HISTORIC AND DESIGN REVIEW COMMISSION

HDRC CASE NO: 2019-278
ADDRESS: 2265 AUSTIN HWY
LEGAL DESCRIPTION: NCB 12162 BLK LOT 18 CLEAN WERKS AUSTIN HIGHWAY
ZONING: C-2
CITY COUNCIL DIST.: 2
APPLICANT: Debra Dockery/Debra J. Dockery, Architect, P.C.
OWNER: CITY OF SAN ANTONIO
TYPE OF WORK: Construction of a fire station
APPLICATION RECEIVED: July 15, 2020
60-DAY REVIEW: Not applicable due to City Council Emergency Orders
CASE MANAGER: Stephanie Phillips
REQUEST:

The applicant is requesting final approval to construct a new fire station.

A4.01

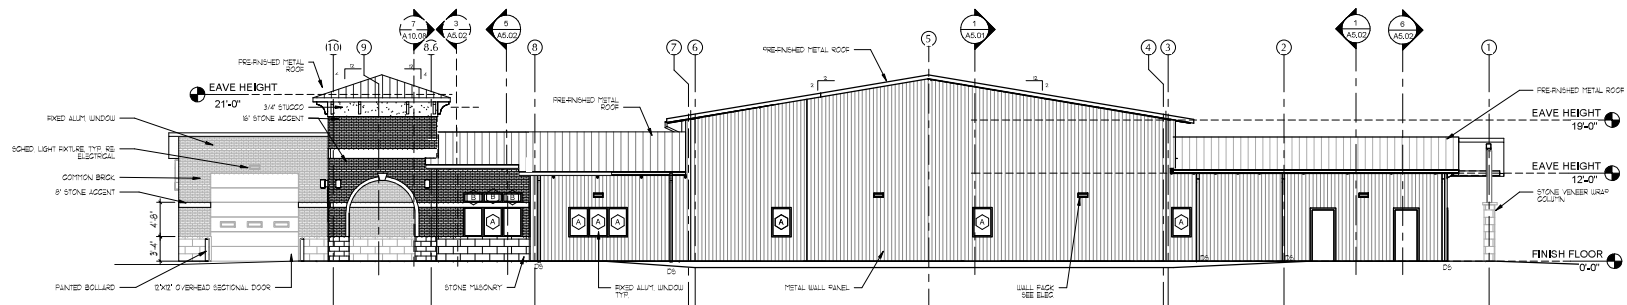
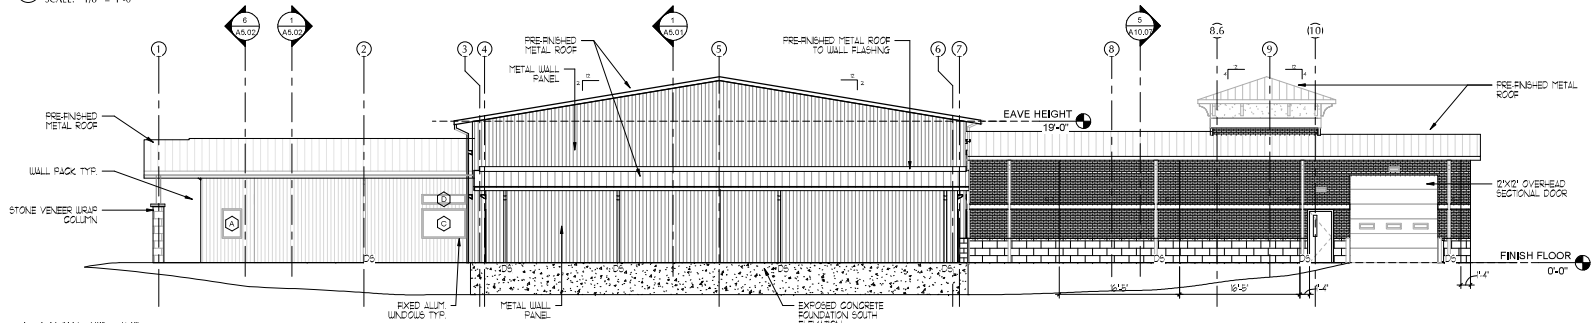
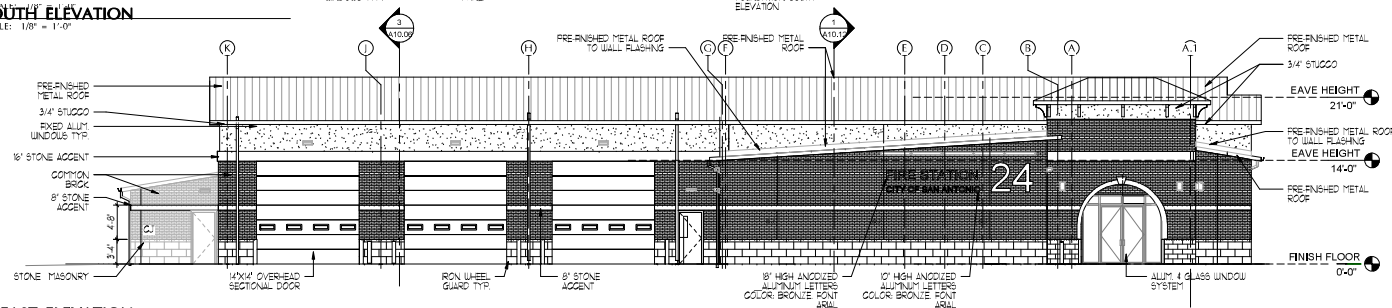
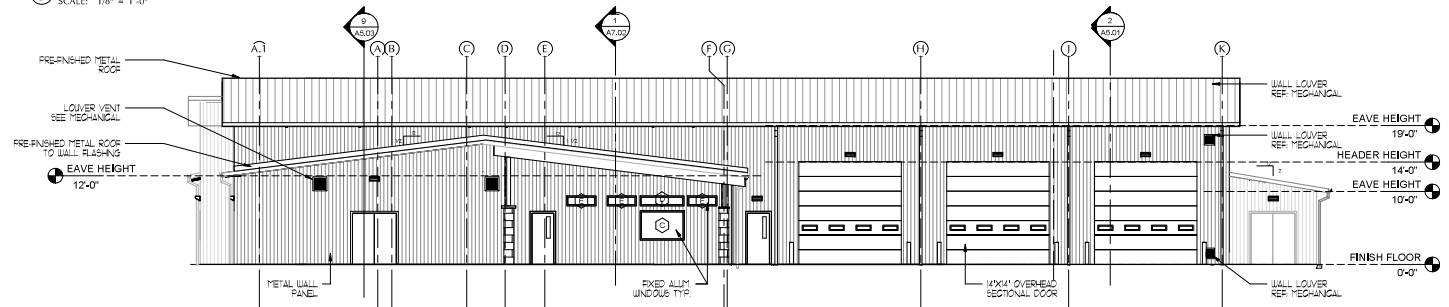
- c. SCALE AND DESIGN – According to UDC Section 35-642, buildings should be designed to be in scale with their adjoining surroundings and harmonious with the surrounding characteristics of the neighborhood. Scale and massing should be compatible with the adjacent area and the design should reflect the highest quality standards. Based on the submitted site plan and drawings, the front of the building, which will face the direction of existing 1-story commercial facilities, will have a multislope roofline that is primarily 1-story in height and a tower with modern Spanish Eclectic details. Staff finds that the proposed structure is consistent with the UDC.

- d. MATERIALS – The applicant has proposed a metal roof and a combination of brick, stucco, stone masonry, and metal paneling for the façade. The applicant is responsible for complying with the UDC regarding materiality, which states that materials should be suitable to the building typology and should be human scale at the pedestrian level. Colors should be harmonious with the surrounding environment. Staff finds the proposal appropriate. The applicant is responsible for obtaining a variance for any materials as applicable.

- h. SIGNAGE – The submitted renderings and drawings indicate potential proposed signage, but to not include detailed drawings. The applicant is required to submit final signage design details to staff prior to the issuance of a Certificate of Appropriateness.
- i. ARCHAEOLOGY – The project shall comply with all federal, state, and local laws, rules, and regulations regarding archaeology.

- i. That the applicant submits comprehensive information on proposed signage prior to the issuance of a Certificate of Appropriateness. The signage shall comply with all applicable sections of the UDC.
- ii. That the applicant obtains a variance for any material specifications as applicable as noted in finding d.
- iii. That the proposed landscaping buffers and plans comply with all applicable sections of the UDC.
- iv. ARCHAEOLOGY – The project shall comply with all federal, state, and local laws, rules, and regulations regarding archaeology.
